DECISION, CONDITIONS, FINDINGS OF FACT AND CONCLUSIONARY FINDINGS OF THE MCMINNVILLE HISTORIC LANDMARKS COMMITTEE FOR THE APPROVAL OF A NEW BUILDING AT 118 NE THIRD STREET WITHIN THE DOWNTOWN DESIGN AREA

DOCKET: DDR 4-19 (Downtown Design Review for New Construction including Waiver Requests)

REQUEST: Approval of the exterior design of a new building to be constructed on the subject property. The proposal includes the demolition of the two existing First Federal buildings that are located on the property today, the construction of a new building oriented towards the corner of Baker and Third Street, and the reconstruction and reconfiguration of all of the parking lots and drive aisles on the property. As part of the review of the building design, the applicant is requesting waivers from the following 5 (five) downtown design standards:

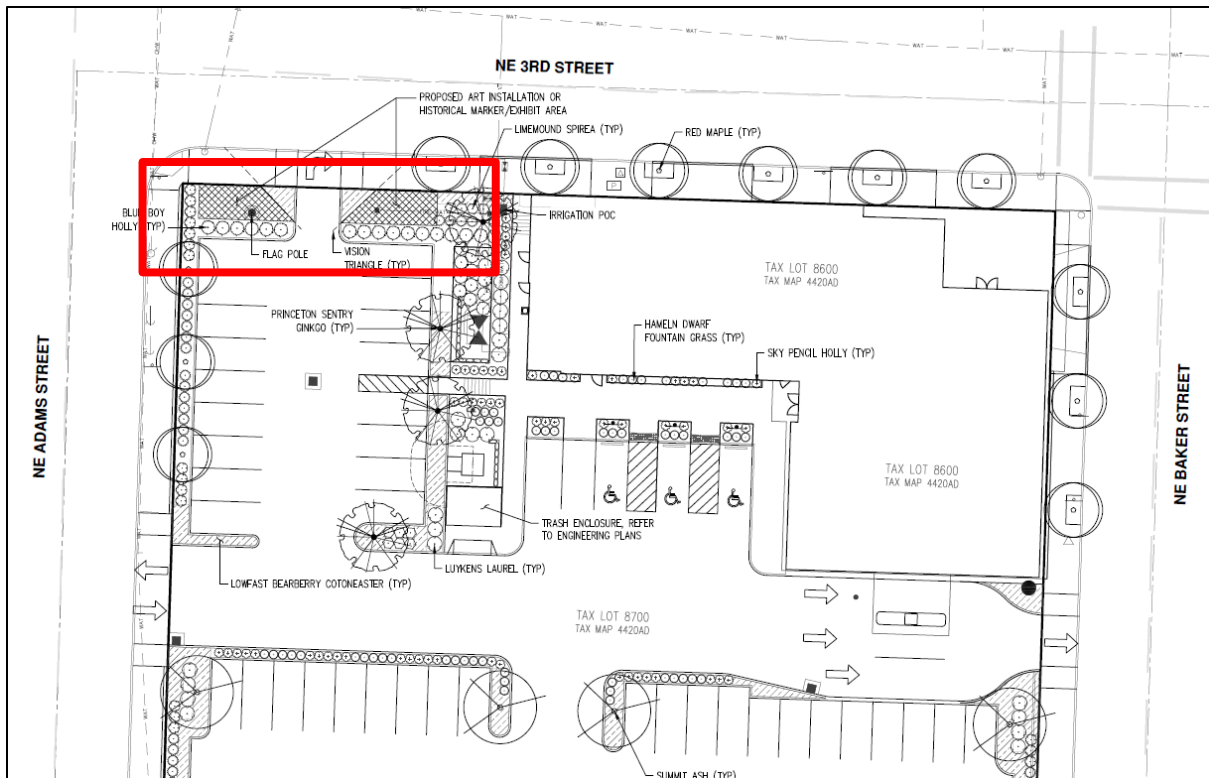
FINDING: SATISFIED WITH CONDITION #1. The City concurs with the applicant’s findings. A condition of approval is included to require that the improvements within the proposed “Historic/Art Area” be designed and installed through the collaborative process described by the applicant. The condition of approval specifies that the “Historic/Art Area” shall be located on both the west and east sides of the right-turn only egress, and on each side shall be a minimum dimension of 25 feet wide and 15 feet deep, as shown on the submitted site plan. The condition of approval also specifies that the “Historic/Art Area” shall not simply be an increased landscape planting area, but that it incorporate some or all of the features described by the applicant such as statues, art, decorative wall, and/or historic district gateway/monument signage. The condition of approval also specifies that some feature with verticality be provided to screen the parking lot from view from Third Street.

The proposed site plan and preliminary landscape plan for the building and development show the location of the surface parking lot and the historic monument area described by the applicant.

1. That the improvements within the proposed “Historic/Art Area” be designed and installed through the collaborative process described by the applicant, which was to design and develop this area through a decision process by Applicant’s Board with input from Planning Department staff, and Steve Rupp, chair of the Downtown Public Arts Committee. The “Historic/Art Area” shall be located on both the west and east sides of the right-turn only egress, and on each side shall be a minimum dimension of 25 feet wide and 15 feet deep, as shown on the submitted site plan. The “Historic/Art Area” shall not simply be an increased landscape planting area, but it shall incorporate some or all of the features described by the applicant such as statues, art, decorative walls, and/or historic district gateway/monument signage that is accessible and uniquely adds value to the pedestrian experience. The “Historic/Art Area” shall also incorporate some feature with verticality to screen the parking lot from view from Third Street.

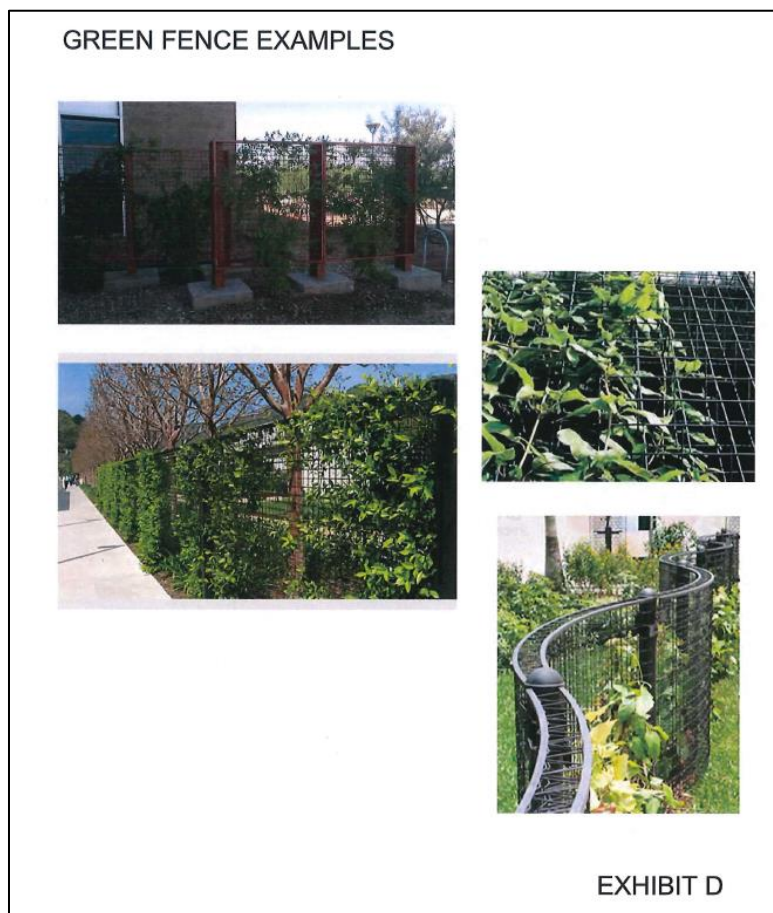
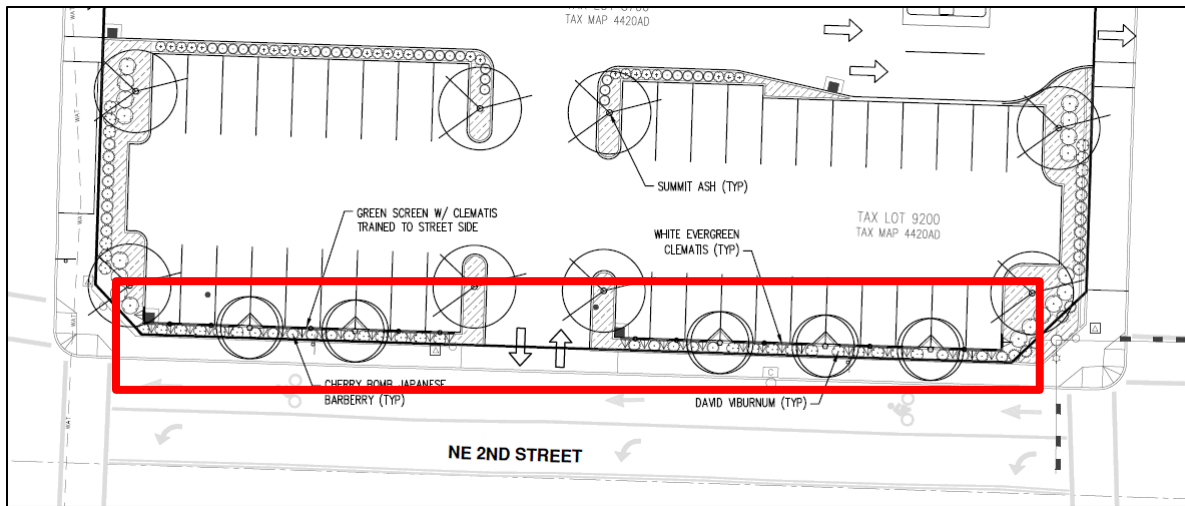
Additional Applicant Response from Supplemental Submittal: Applicant believes it has adequately addressed and has met the circumstances necessary to support this waiver. See pages 12-14 of Applicant’s Land Use Application Revised August 01, 2019. Applicant would again stress the significant numbers of employees, and also customers who use these parking lots and drive extended and four door pickups which require significant maneuvering space.

FINDING: SATISFIED. The City concurs with the applicant’s findings. While some reductions in drive aisles could have been pursued to allow for the 5 foot landscape buffer per Section 17.60.080(G), the City finds that the alternative design proposed by the applicant accomplishes the purpose of the Downtown Design Standard Chapter, as described below.

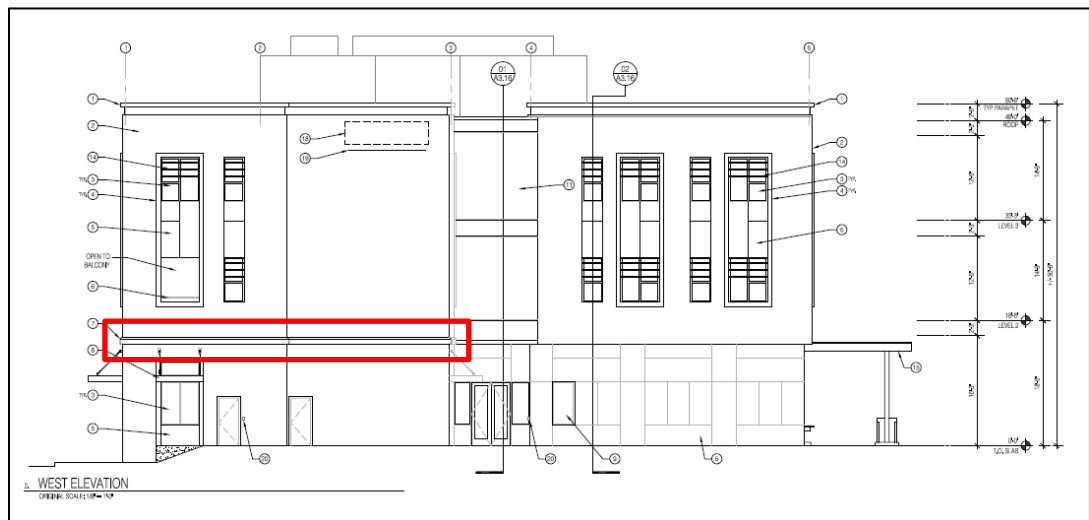
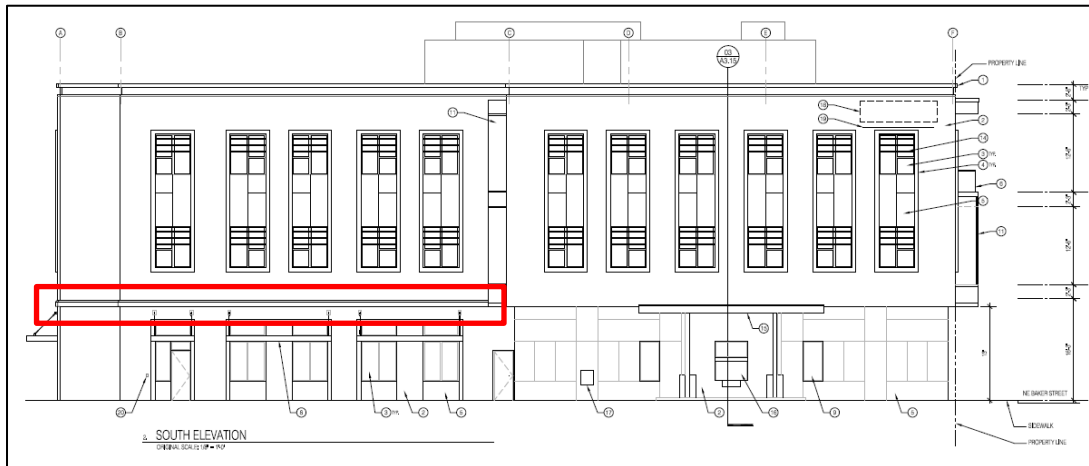
APPLICANT’S RESPONSE: The building has a precast-concrete belt course along the partial north and south facades and along the entire west façade. To continue this architectural feature, the remaining part of the facades have a brick soldier course aligned with the precast belt course. This belt course is approximately 15 feet above the first floor. We believe these elements meet the intent of the design criteria.

FINDING: SATISFIED WITH CONDITION #4. The City concurs with the applicant’s findings. However, the brick soldier course described by the applicant is not identified in the building elevations or the building renderings. Therefore, a condition of approval is included to require that the construction plans submitted for building permit review include a detail of the proposed brick soldier course along all areas of the façade that do not include a precast concrete belt course. The soldier course shall be at the same height as the precast concrete belt course.

4. That the applicant shall include a detail of the proposed brick soldier course along all areas of the façade that do not include a precast concrete belt course in the construction plans submitted for building permit review. The soldier course shall be at the same height as the precast concrete belt course between the first and second stories of the building.

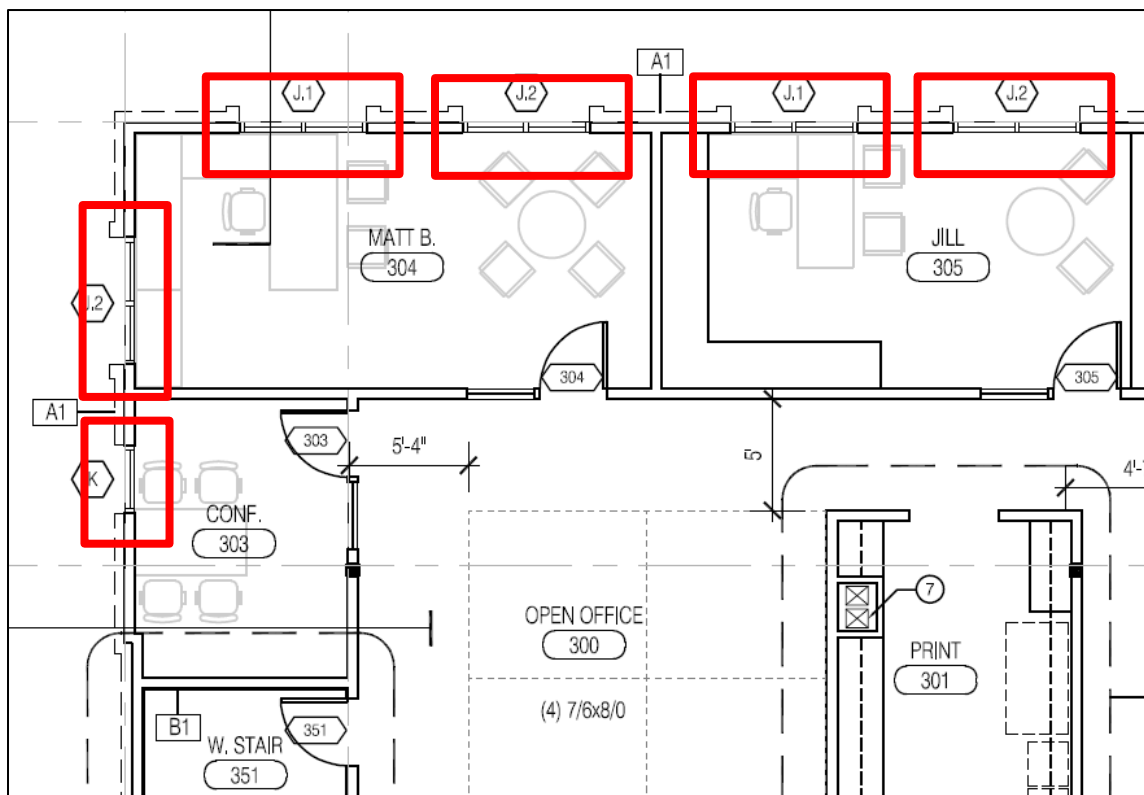
FINDING: SATISFIED WITH CONDITION #5. The City concurs with the applicant’s findings, but adds that no details for the windows were provided. Detail numbers were identified in the plan set on the floor plans, but were not included in the submittal. Therefore, a condition of approval is included to require that the construction plans submitted for building permit review include window details depicting that all of the windows on the building will be recessed.

The renderings and floor plans do identify recessed windows both on the ground floor and the upper stories, as shown below (note – the floor plan provided is of the third floor but is typical of what is identified on the full floor plan drawings):

5. That the applicant shall include window details in the construction plans submitted for building permit review that depict that all of the windows on the building will be recessed.

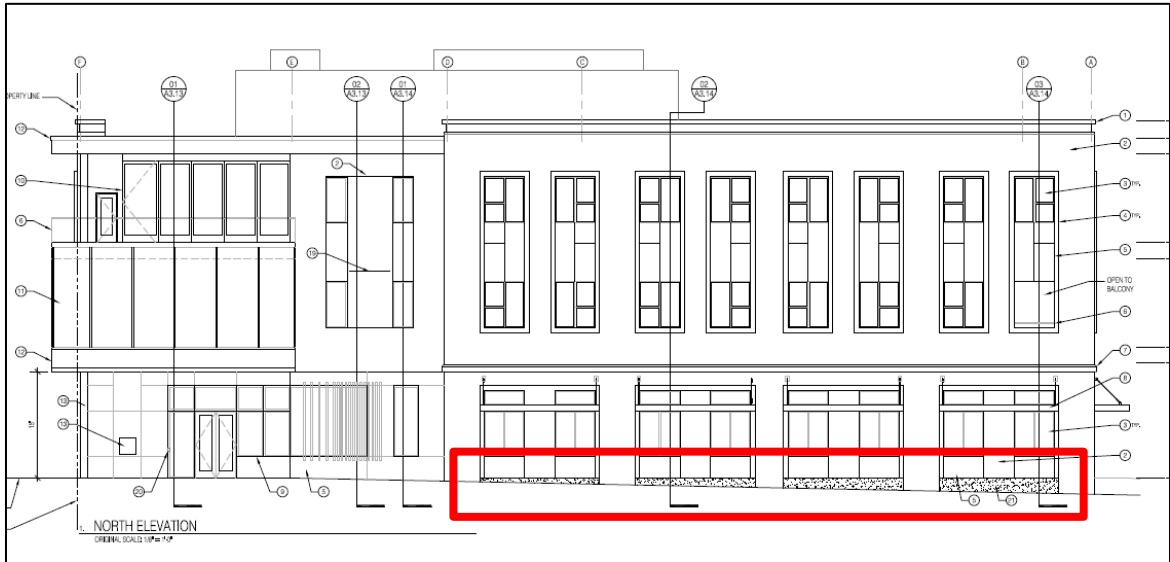
One portion of the façade that is identified differently in the elevation drawings and the renderings is the exposed foundation beneath the windows on the western portion of the 3rd Street façade. This portion of the façade is identified in the elevation on Exhibit C9 as “Exposed Foundation Wall, Skim Coat”, but shows up in the renderings as a consistent material beneath the windows to the sidewalk. The applicant has verified that the elevation drawing is correct, and that the exposed foundation wall would be visible in these areas of the façade, and finished with the cement plaster that is similar to smooth stucco. In order to maintain a cohesive finish beneath the windows and for consistency in this area that is

described as the bulkhead in other areas of the application narrative, a condition of approval is included to require that the skim coated exposed foundation wall be painted a tan color to match the stone panels that will be installed above the exposed foundation wall and beneath the windows. Alternatively, the applicant may install the stone panel material over the foundation wall to encompass the entire area from the bottom of the window to the sidewalk.

This discrepancy between the elevation drawings and the renderings can be seen below:
